Georgetown County, South Carolina

ADDENDUM #1 TO BID #21-040 REBID

PROCUREMENT FOR: Big Dam Swamp Recycle Center-General Contractor

PHOTOS OF OILSHED STRUCTURE
(SAME REQUIRED FOR THIS PROJECT)

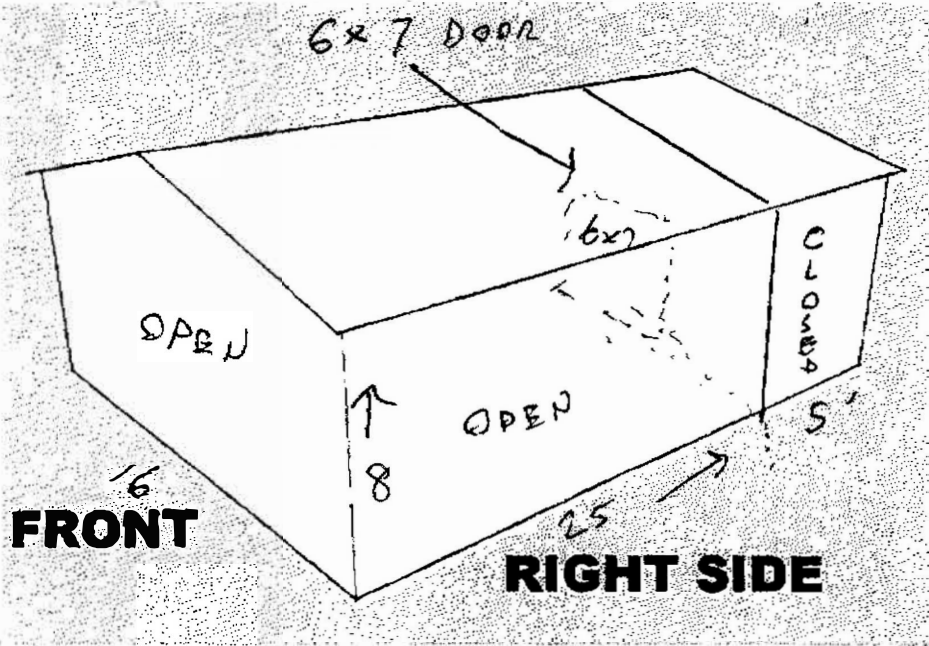
Question #3:   Please provide clarification as to the requirements for the utility structure (oil Shed structure). The bid document state a 30'x16' partially enclosed oil shed structure is required. Included with the bid documents are approximately 29 pages of Custom Built Structures drawing. These drawings include every type of building and component that Custom Built Structures sales. Nowhere in the documents are there any design details stating what is required for this 30'x16 partially enclosed oil shed structure.

Please provide details as to the requirement for the 30'x16' partially enclosed oil shed structure so that we may obtain pricing.

Details should include height of the structure, define which walls shall have wall panels, heights of the wall panels for the partially enclosed structure, gauge of metal wall and roof panels, define if roof and wall panels should receive painted or galvanized coatings, etc.

Response: The example provided in the bid documents prepared by Custom Built Structures is a typical example. The county recently purchased one of these from Custom Built Structures. The invoice is attached, which contains the dimensions and selected options. This is the same structure that is specified for this project. Also, photos of the installed structure are below (Note: A sump is required in the slab for this project, per Drawing C-13). The contractor may submit to the County for approval an "approved equal" structure from another supplier, provided that it is stamped by a licensed PE for wind loading/structural.
